Subject: IFB16-1804OV, Satellite Lift Station R & R, 2015 Group 1
(Project No. 402-0019707 / 5001301)
ADDENDUM #1

IFB16-1804OV, Satellite Lift Station R & R, 2015 Group 1

WILDWOOD SPRINGS 2 / RTU 115

PALMA SOLA WOODS 1 – RTU 214

US-19

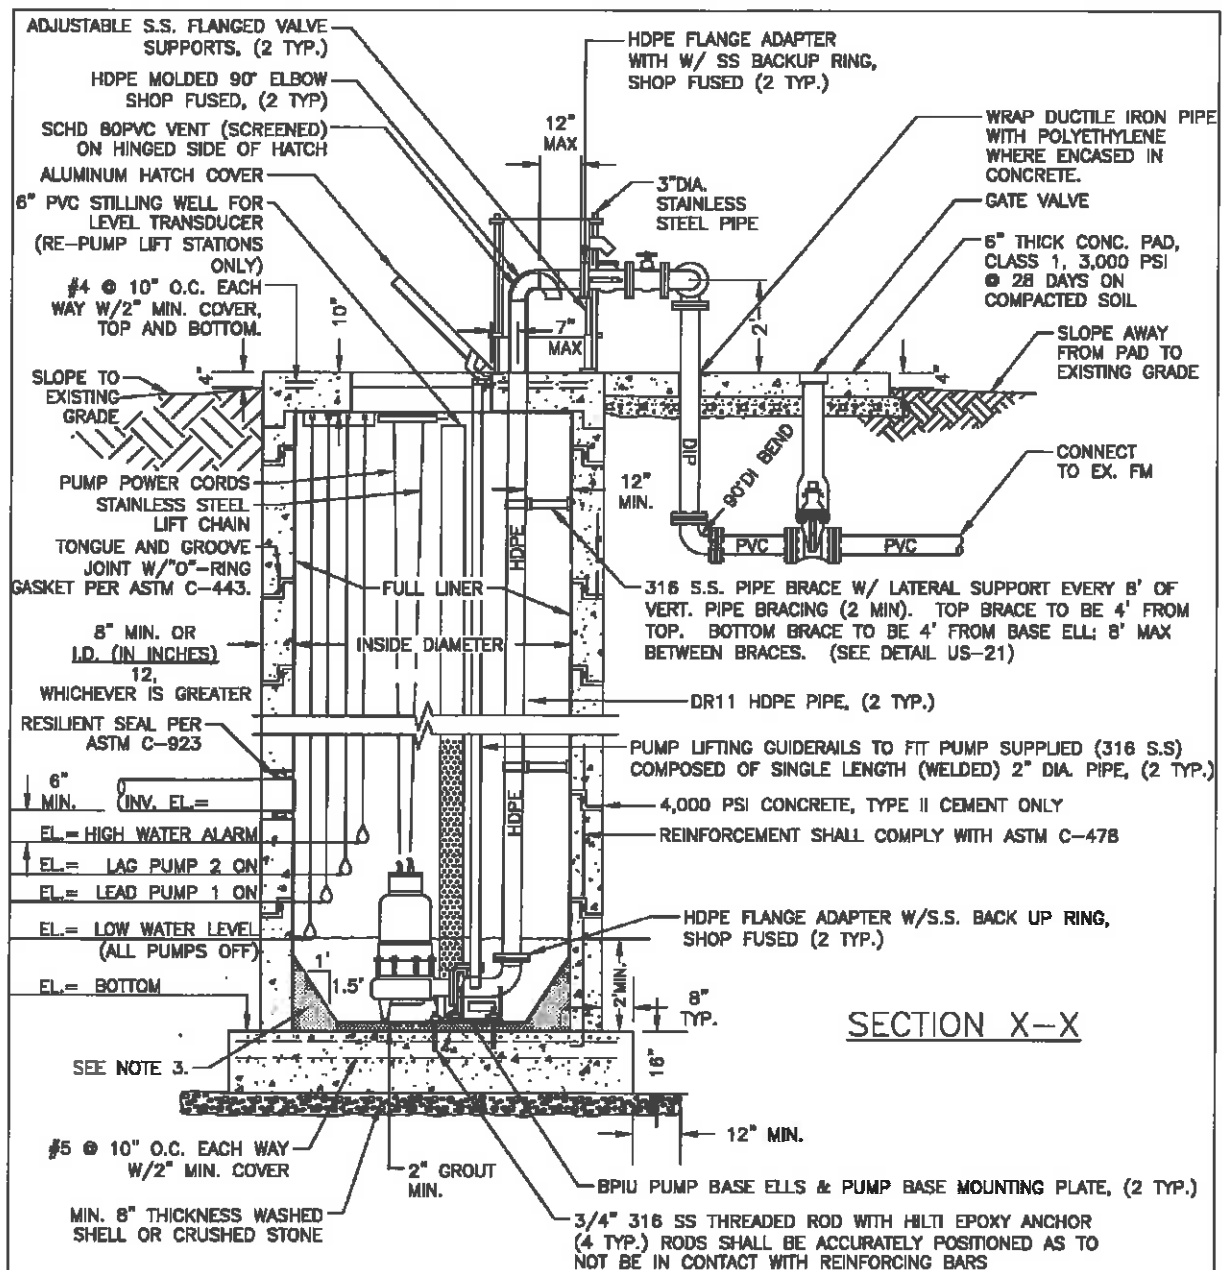
Q7. Please provide a detail for rebar reinforcement for the new wet-well tops and concrete pads for above ground valve assembly.

R7. Please refer to the Manatee County Public Works Standards. All Contractors are encouraged to have a copy for reference. These documents are available on <http://www.mymanatee.org/home/government/departments/publicworks/engineering-services/engineering-standards.html> for download in a portable document format (.PDF). Per the attached version of "sewage Pump Station Section View (US-19)", the reinforcement is called out to be a #4 bars@ 10" on center each way with two inches minimum cover top and bottom. The rebar should be embedded in 4,000 psi concrete, type II cement.

R8. The thickness should be 10" per the Manatee County Public Works Standards.
